IN THE MATTER OF Stage 3 Proposed District Plan – General Industrial
Zone

BETWEEN Cardrona Cattle Company Limited (Submitter
#3349)

SITE Victoria Flats Road

**TRANSPORTATION EVIDENCE OF RAYMOND JOHN EDWARDS IN SUPPORT OF
THE SUBMISSION OF CARDRONA CATTLE COMPANY LIMITED (Submitter #3349)**

Gibbston Highway- Proposed Roundabout and updated road layout

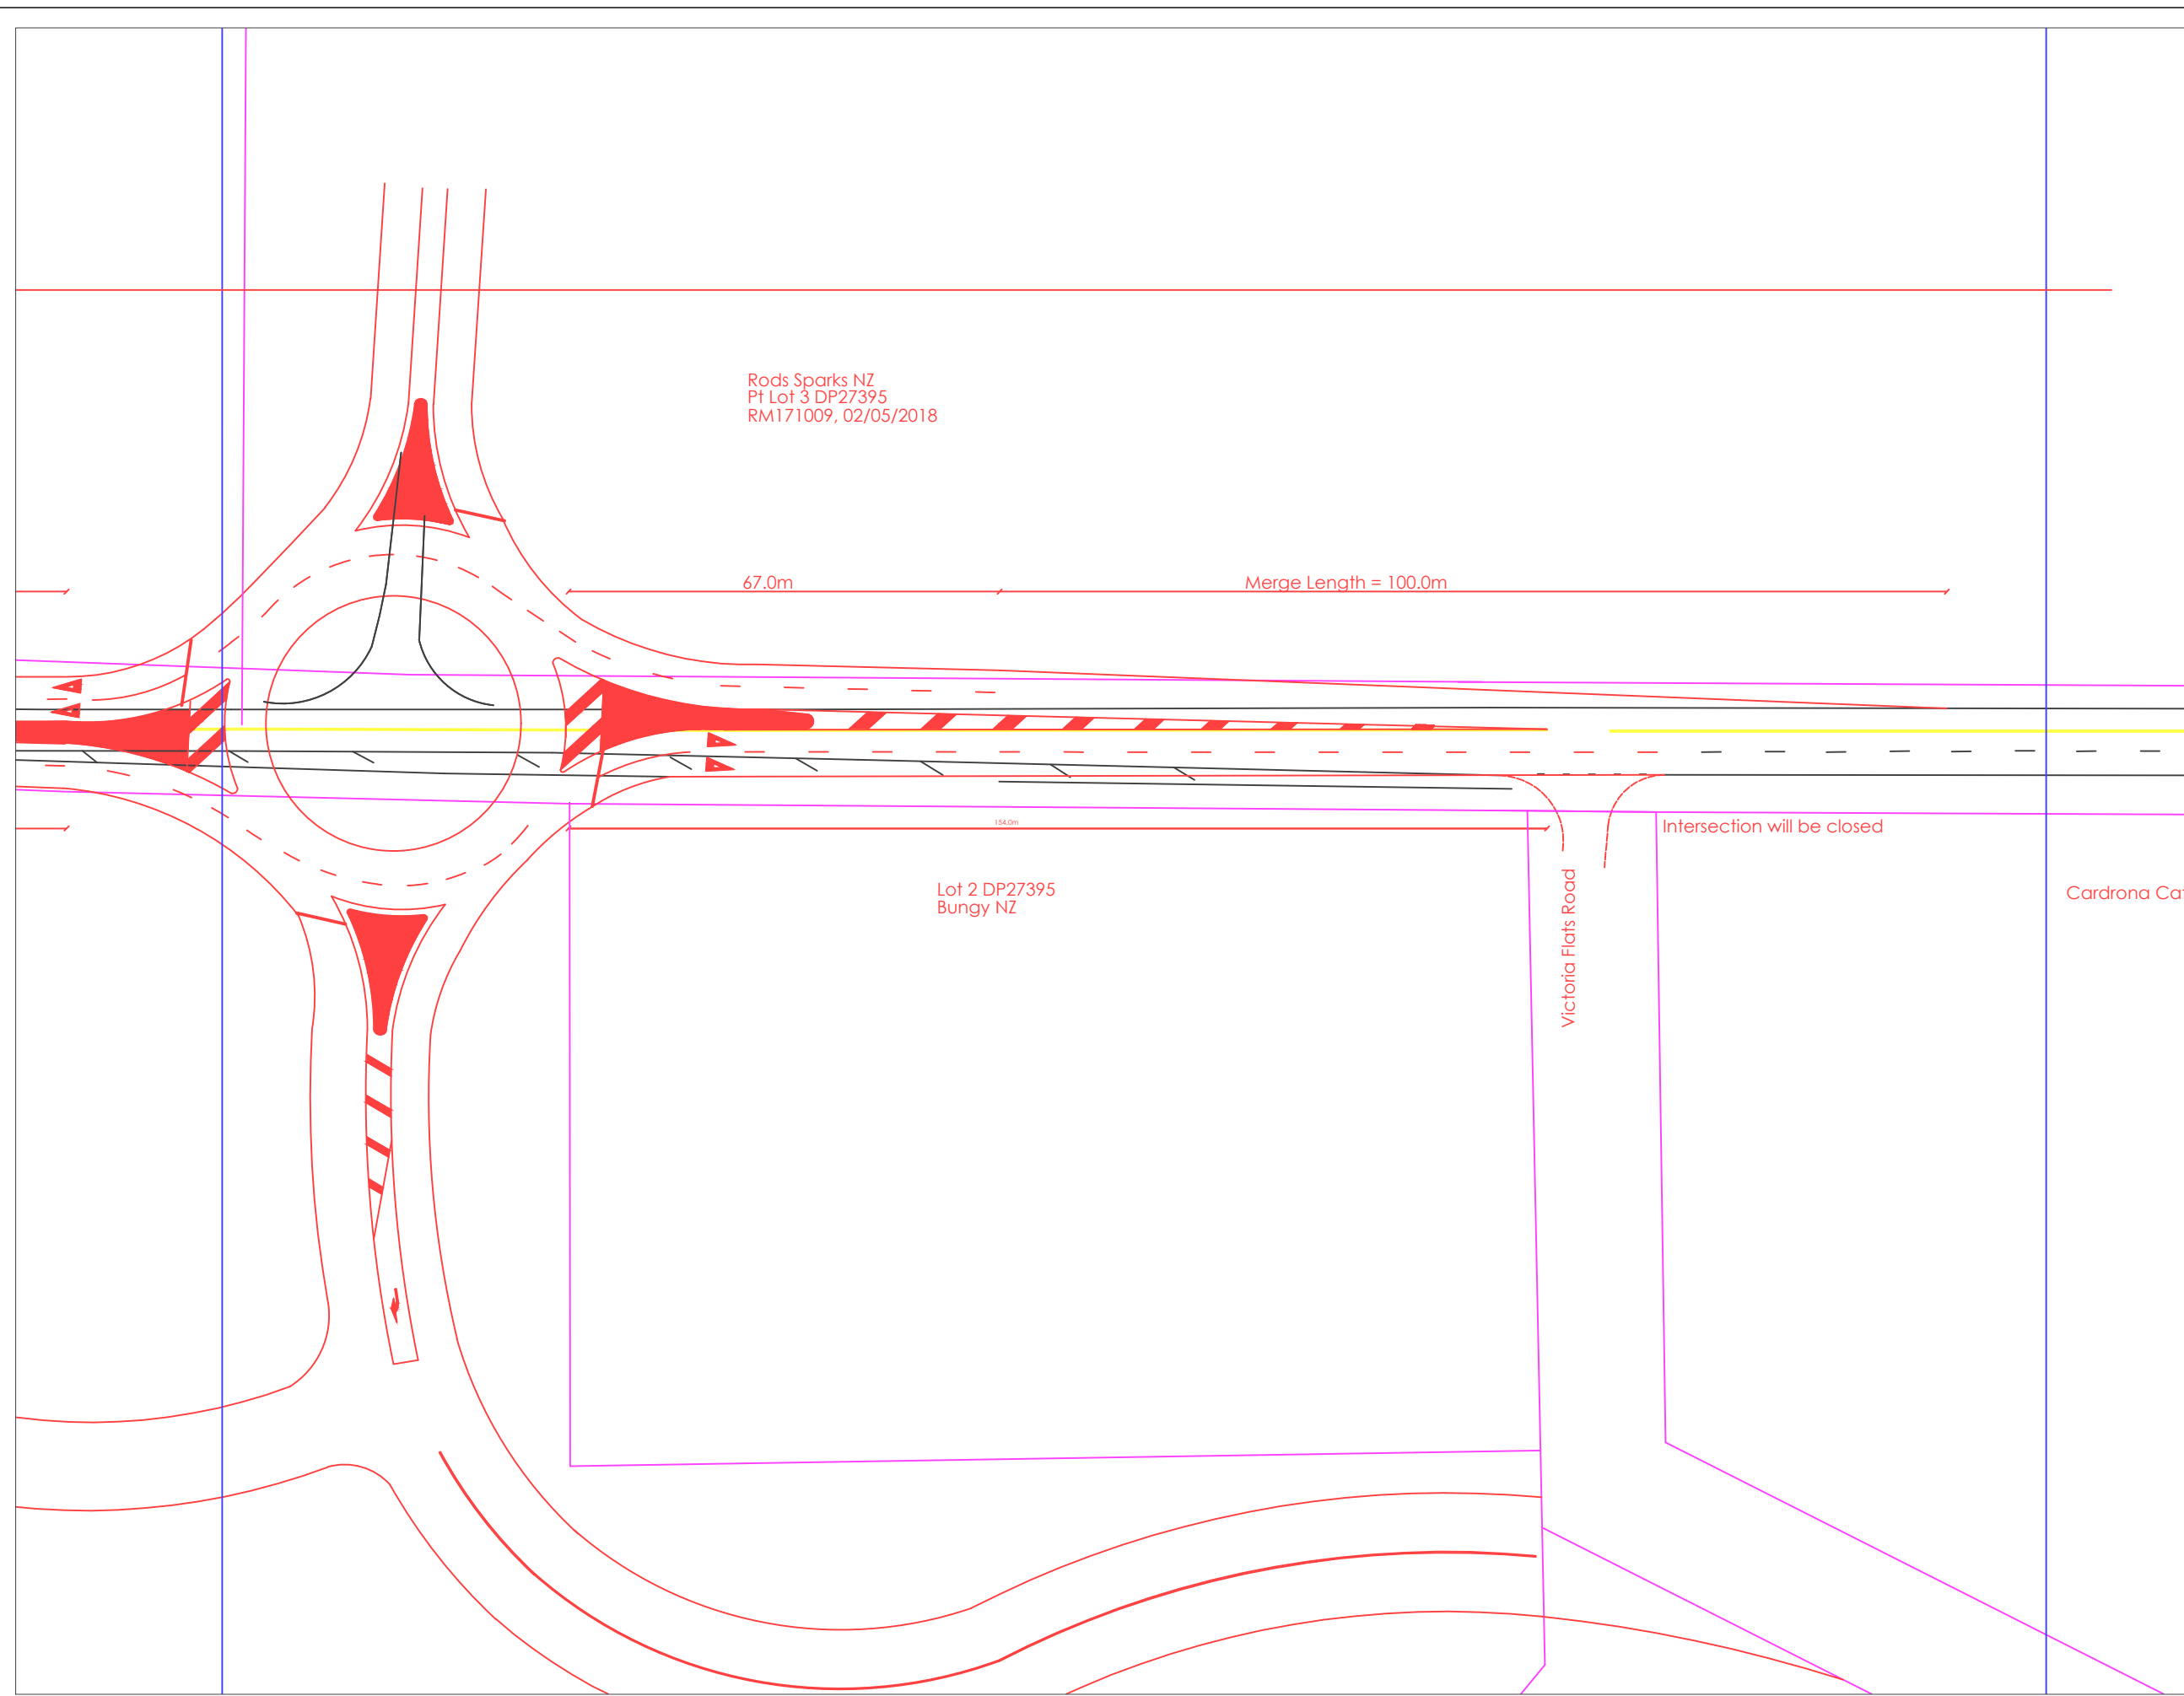
Thank you for providing the information on your client's wider proposal for Victoria Flats. The information provided included the traffic assessment conclusions for the wider development for Victoria Flats (Stage 2) and plans for an interim priority control intersection at Victoria Flats Road and SH6 as well as the potential for a roundabout should significant development occurs in the future. Information and links were also provided for the applicant's submission to the Queenstown Lakes District Proposed District Plan (Proposed Plan) for this area.

- The potential scale and intensity of the proposed landuse. We note the Council Officers report for the Proposed Plan recommendation is to reject your client's and Waitiri Ltd submissions to rezone the land in this area to Gibbston Industrial. As a result, we consider the outcome of the Proposed Plan process is likely to affect the scale of the Masterplan.

- The Agency also has concerns around the scale of industrial and residential landuse presented in the Masterplan and the appropriateness of the location for these activities. Also, following on from this – concerns around what the nature of the landuses that may be attracted to this location if the Masterplan went ahead, and;

- The information provided to date does not include an assessment of how the activities represented by the Masterplan will affect the overall capacity of highway network and in particular the capacity of the Shotover Bridge.

Therefore, assessing plans for road improvements with a view to providing the Agency written approval to the Masterplan is considered premature at this point. However, we do note if the proposal goes forward and a resource consent application is prepared (or a application for a private plan change) that, subject to an assessment of effects of the proposal on the highway network capacity, an engineered solution for road improvements to mitigate the effects on the highway could be identified.

Once your client is at the point where the Masterplan can be refined further, and a resource consent application is being prepared we would be happy to revisit this proposal.
